Miroo Desai, AICP
Planning Manager
City of Emeryville, CA

I am submitting these comments regarding the scope of the Environmental Impact Report for Sutter Health's proposed Emeryville Medical Center.

Figure 5-3: Current Designated Pedestrian Priority Zones

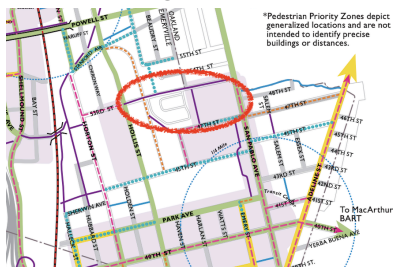
- Every school day, students from 3 schools converge on one block to get to school, but 53rd Street is not yet a pedestrian priority zone in the General Plan (Figure 5-3; see next page). Currently, there's an interesting gap. While the school section itself is zoned as pedestrian priority, the street that most students use to get to school is not.
- When addressing project consistency in future reviews, City to evaluate amending the General Plan to apply Pedestrian Priority Zone designation to the entire 53rd Street between Hollis & San Pablo radius. Between Hollis & San Pablo, 53rd Street connects through Emery Bay Village multi-family housing, Spur Alley (including a youth gymnastics center), a preschool, an elementary school, a middle school, and a high school.

5. **Zoning designation for 53rd Street radius:** Amend General Plan to apply Pedestrian Priority Zone designation to entire 53rd Street between Hollis & San Pablo radius. Between Hollis & San Pablo, 53rd Street connects through Emery Bay Village multi-family housing, Spur Alley (including a youth gymnastics center), a preschool, an elementary school, a middle school, and a high school. *(see public comment annotation in red; Figure 5-3 of City's General Plan)*

Issue: Safety Incompatibility of Traffic Diverted to 53rd Street

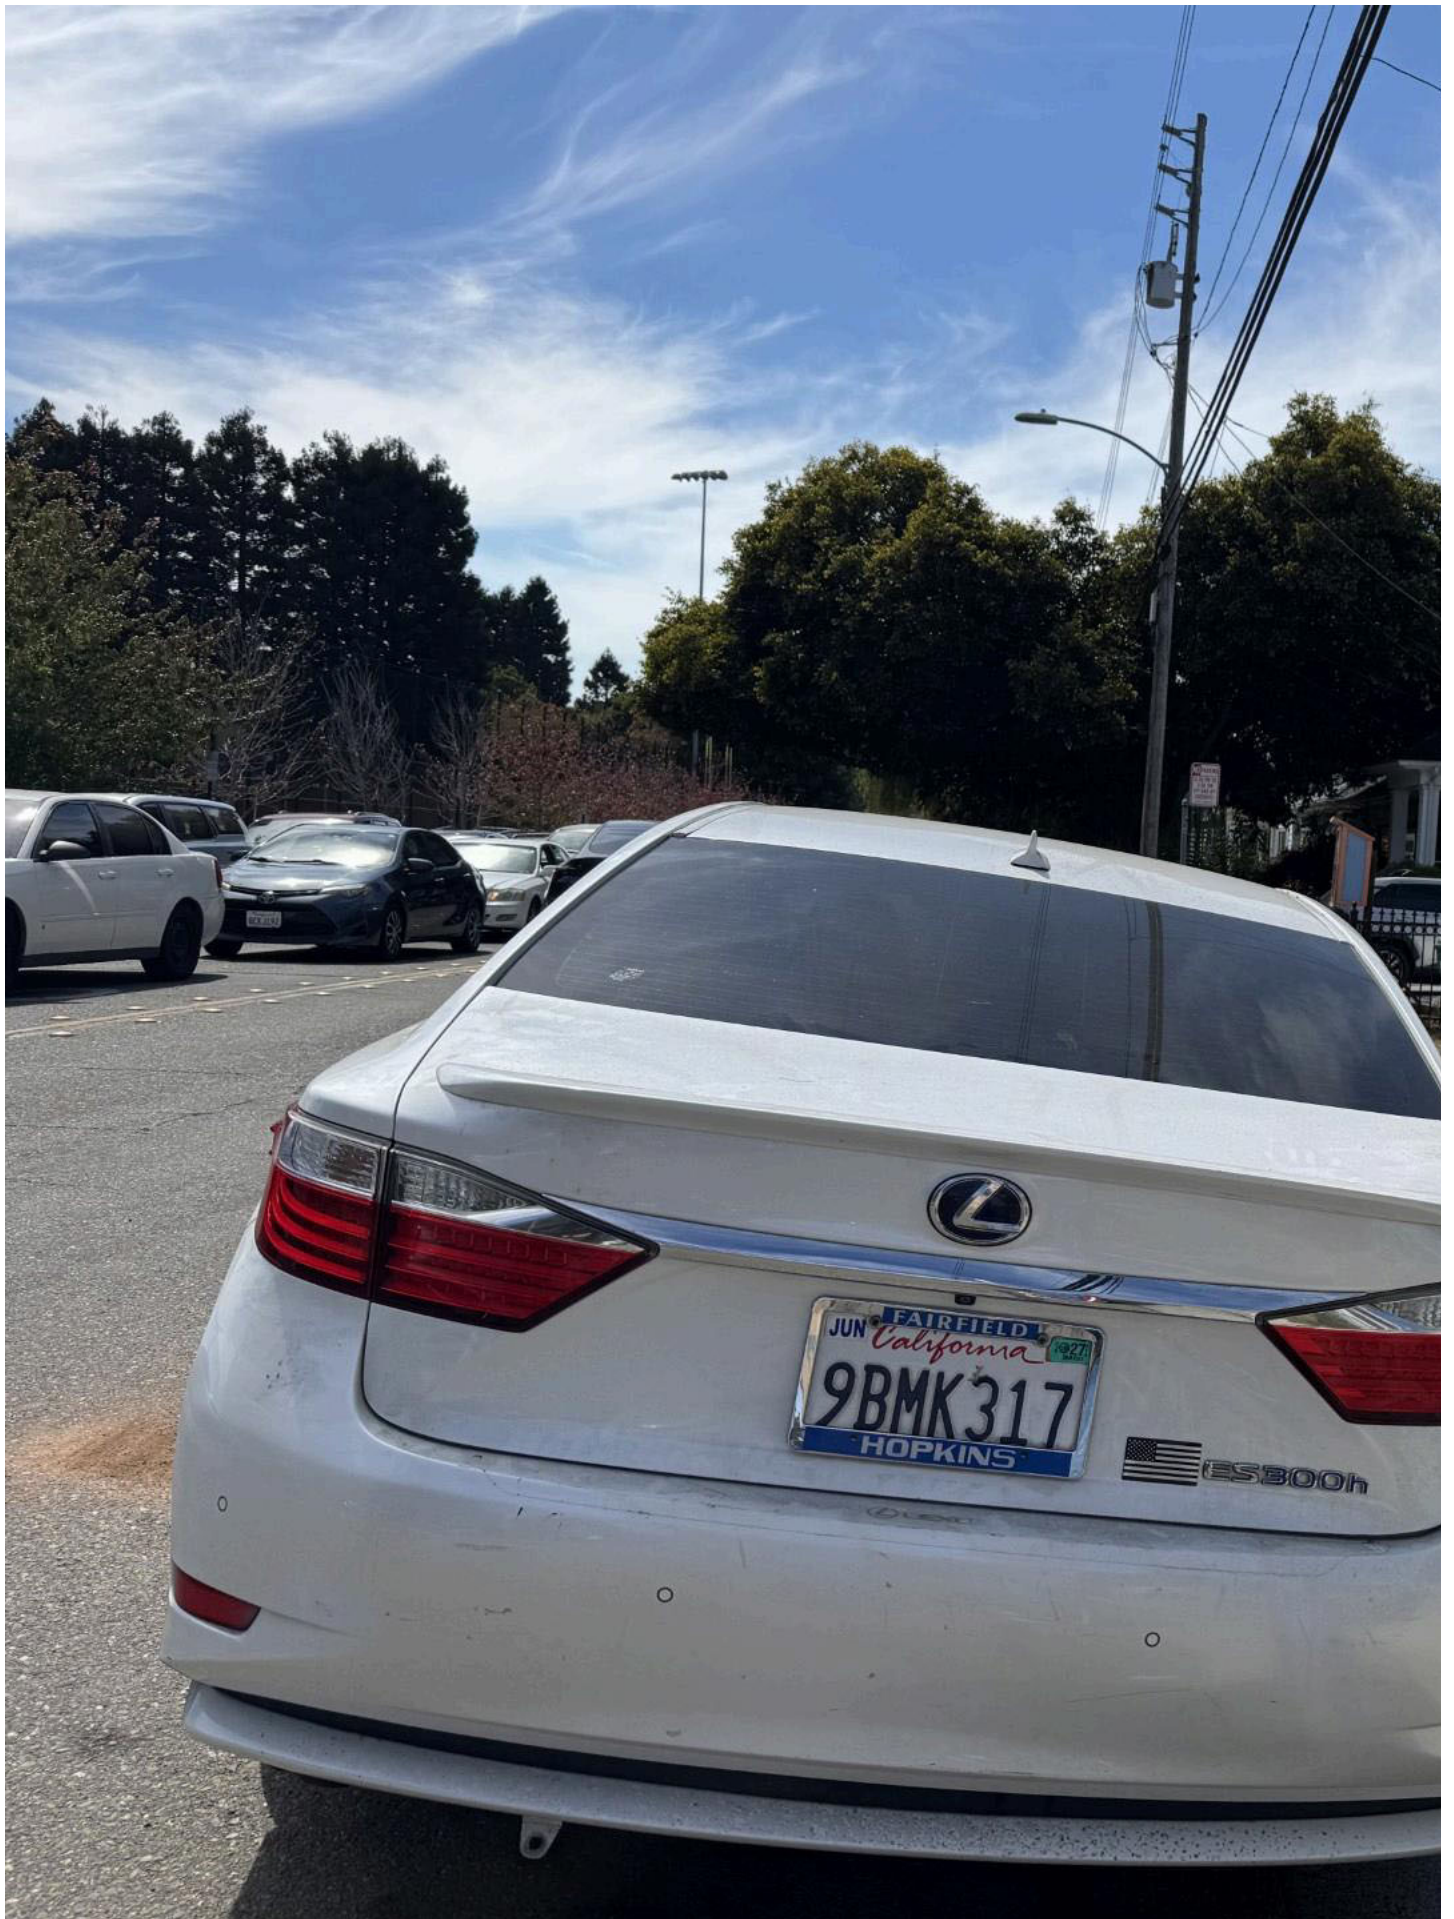
Legal Relevance under CEQA: This documentation provides substantial evidence of a severe structural bottleneck in the existing baseline grid that the Lead Agency's environmental analysis must address under CEQA Appendix G, Section XVII, Questions (a) & (c). Additionally, it demonstrates how local infrastructure has been intentionally modified by the City through multiple plans and programs to restrict rapid vehicle circulation in favor of multi-modal safety.^{1,2}

Request: The EIR must explicitly evaluate how the addition of the projected 1,500–1,800 peak-hour hospital vehicle trips can legally or physically reconcile with diverting high-volume vehicle flow through a 1 lane residential street (considered as "thoroughfare") with 2 schools (1 daycare, 1 K-12).

The EIR must consider the K-12 school drop-off and pickup site mitigation.

EXHIBIT A: 53rd Street / Anna Yates Elementary School Gridlock and Safety Concerns
Date Captured: March 24, 2026 3:03pm
Location: 1114 53rd St, facing east

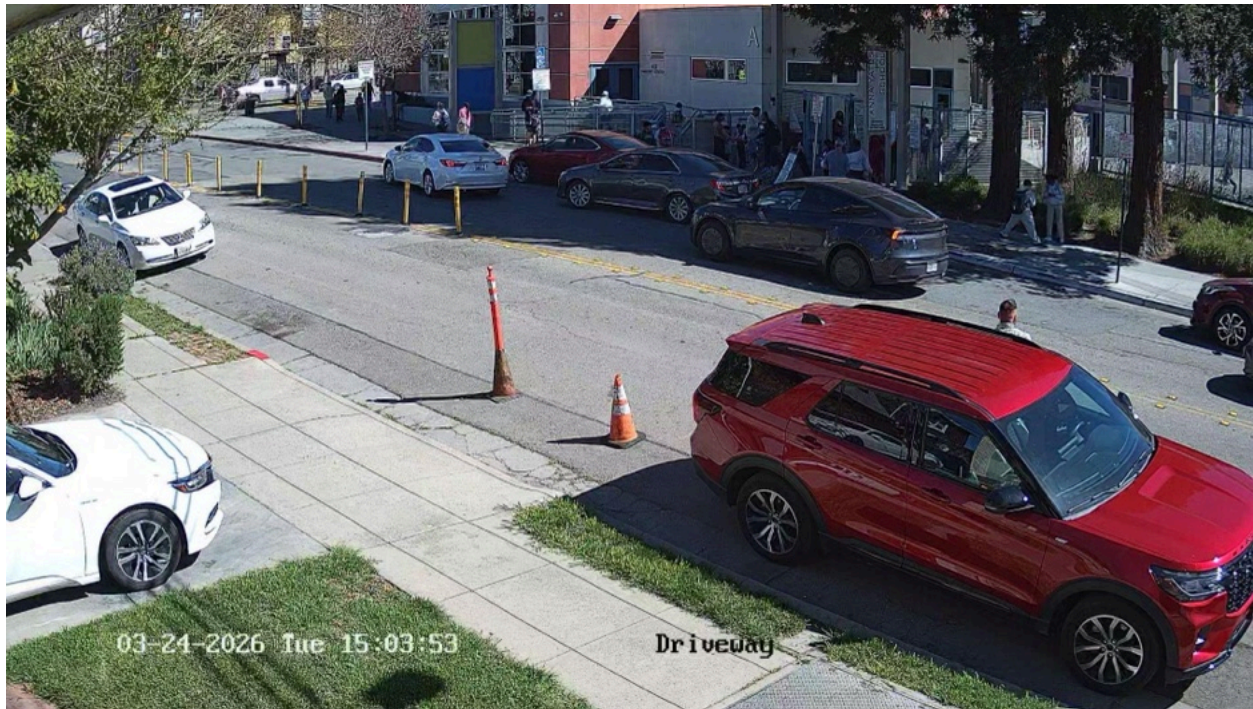
Exhibit Description: The white sedan (top) is double parked, blocking both the traffic lane and a driver attempting to pull away from the curb. The white sedan is parked here for more than 3 minutes.

Location: 1114 53rd St, facing west

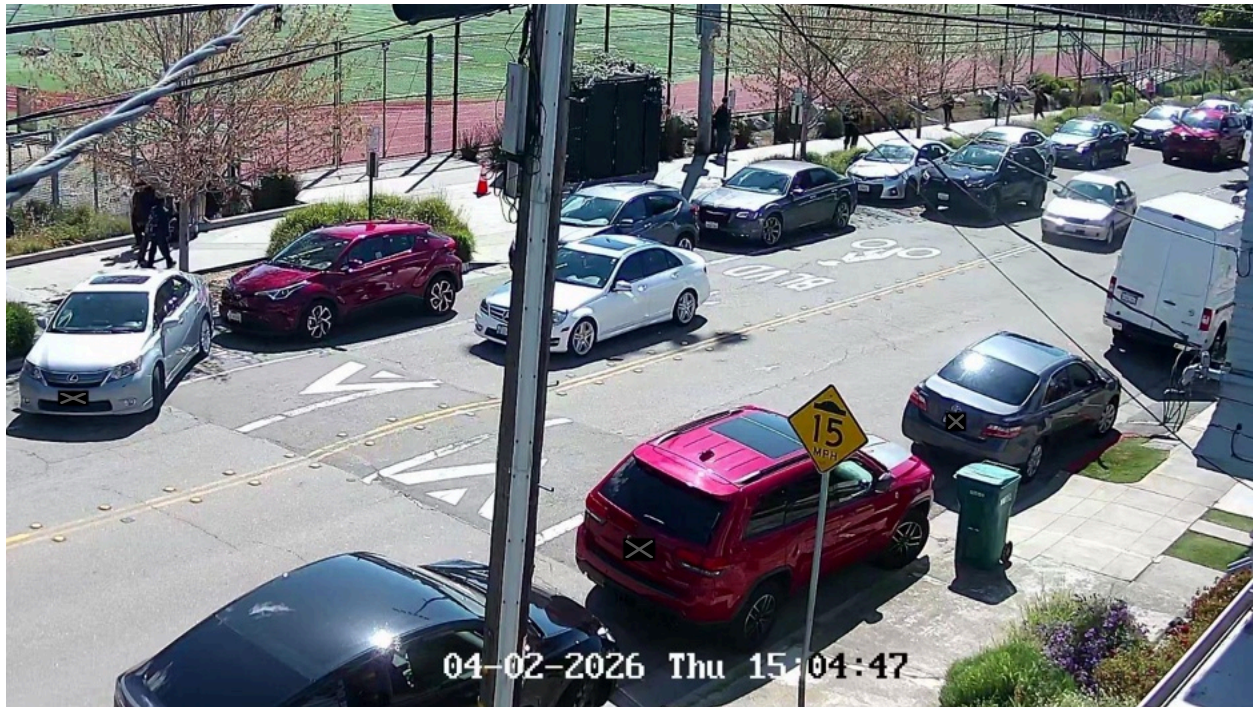
Exhibit Description: The black SUV (top-right) is double-parked in the eastbound lane for more than 8 minutes. In this time, 12 cars use the opposing traffic lane to pass it.

Figure 5-3: Current Designated Pedestrian Priority Zones

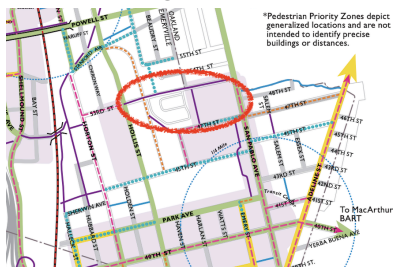
- Every school day, students from 3 schools converge on one block to get to school, but 53rd Street is not yet a pedestrian priority zone in the General Plan (Figure 5-3; see next page). Currently, there's an interesting gap. While the school section itself is zoned as pedestrian priority, the street that most students use to get to school is not.
- When addressing project consistency in future reviews, City to evaluate amending the General Plan to apply Pedestrian Priority Zone designation to the entire 53rd Street between Hollis & San Pablo radius. Between Hollis & San Pablo, 53rd Street connects through Emery Bay Village multi-family housing, Spur Alley (including a youth gymnastics center), a preschool, an elementary school, a middle school, and a high school.

5. **Zoning designation for 53rd Street radius:** Amend General Plan to apply Pedestrian Priority Zone designation to entire 53rd Street between Hollis & San Pablo radius. Between Hollis & San Pablo, 53rd Street connects through Emery Bay Village multi-family housing, Spur Alley (including a youth gymnastics center), a preschool, an elementary school, a middle school, and a high school. *(see public comment annotation in red; Figure 5-3 of City's General Plan)*

Issue: Safety Incompatibility of Traffic Diverted to 53rd Street

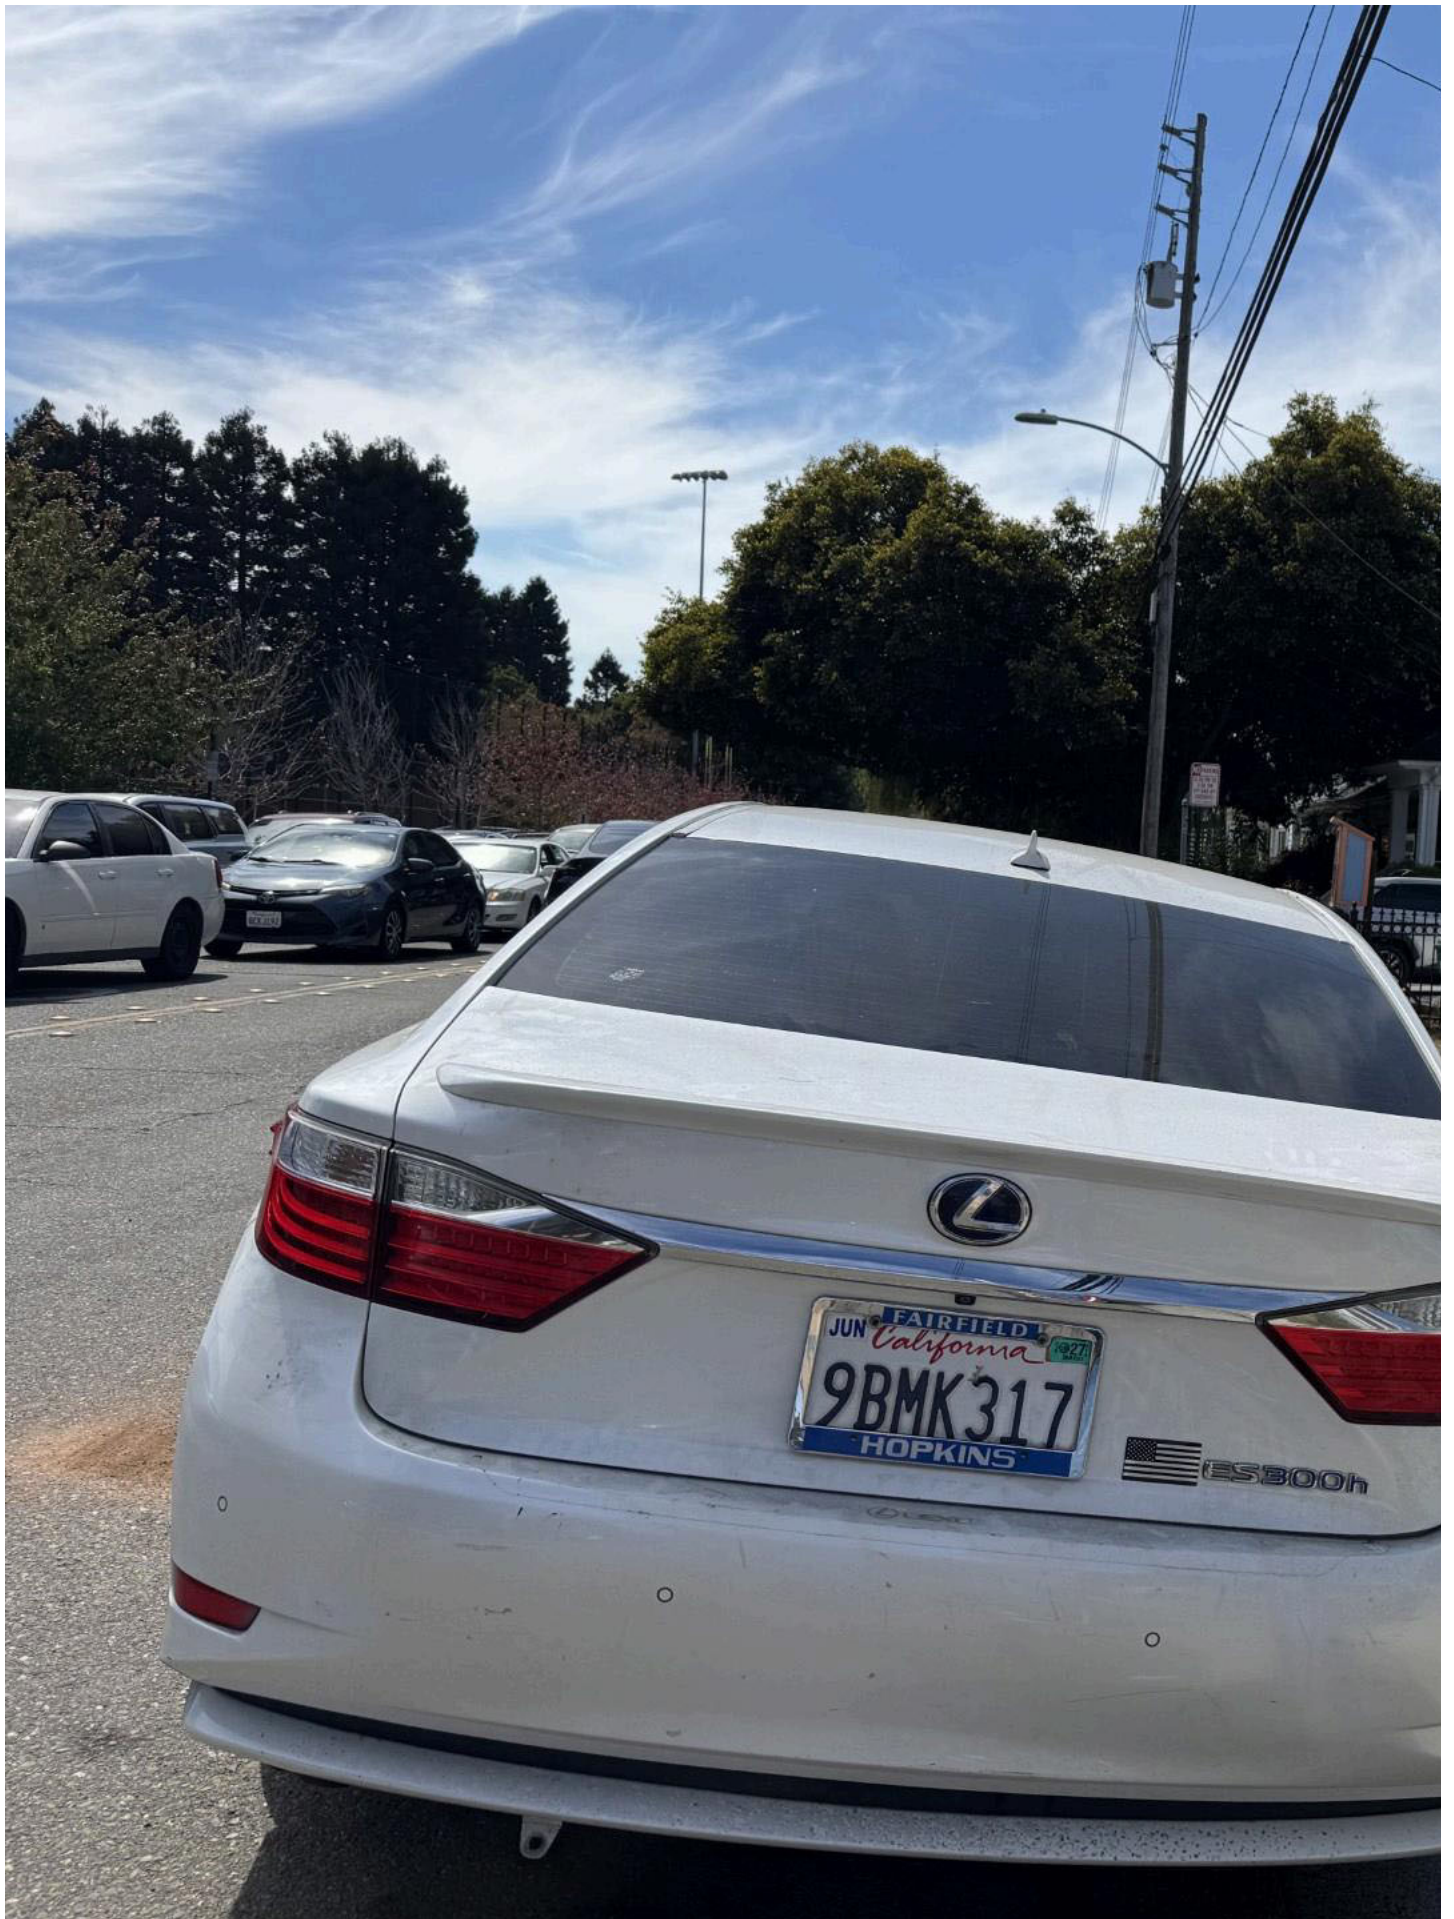
Legal Relevance under CEQA: This documentation provides substantial evidence of a severe structural bottleneck in the existing baseline grid that the Lead Agency's environmental analysis must address under CEQA Appendix G, Section XVII, Questions (a) & (c). Additionally, it demonstrates how local infrastructure has been intentionally modified by the City through multiple plans and programs to restrict rapid vehicle circulation in favor of multi-modal safety.^{1,2}

Request: The EIR must explicitly evaluate how the addition of the projected 1,500–1,800 peak-hour hospital vehicle trips can legally or physically reconcile with diverting high-volume vehicle flow through a 1 lane residential street (considered as "thoroughfare") with 2 schools (1 daycare, 1 K-12).

The EIR must consider the K-12 school drop-off and pickup site mitigation.

Figure 5-3: Current Designated Pedestrian Priority Zones

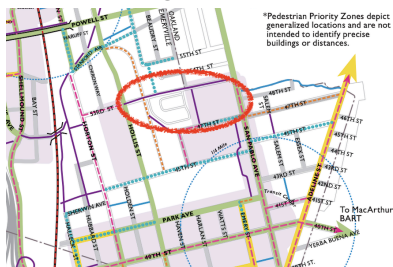
- Every school day, students from 3 schools converge on one block to get to school, but 53rd Street is not yet a pedestrian priority zone in the General Plan (Figure 5-3; see next page). Currently, there's an interesting gap. While the school section itself is zoned as pedestrian priority, the street that most students use to get to school is not.
- When addressing project consistency in future reviews, City to evaluate amending the General Plan to apply Pedestrian Priority Zone designation to the entire 53rd Street between Hollis & San Pablo radius. Between Hollis & San Pablo, 53rd Street connects through Emery Bay Village multi-family housing, Spur Alley (including a youth gymnastics center), a preschool, an elementary school, a middle school, and a high school.

5. **Zoning designation for 53rd Street radius:** Amend General Plan to apply Pedestrian Priority Zone designation to entire 53rd Street between Hollis & San Pablo radius. Between Hollis & San Pablo, 53rd Street connects through Emery Bay Village multi-family housing, Spur Alley (including a youth gymnastics center), a preschool, an elementary school, a middle school, and a high school. *(see public comment annotation in red; Figure 5-3 of City's General Plan)*
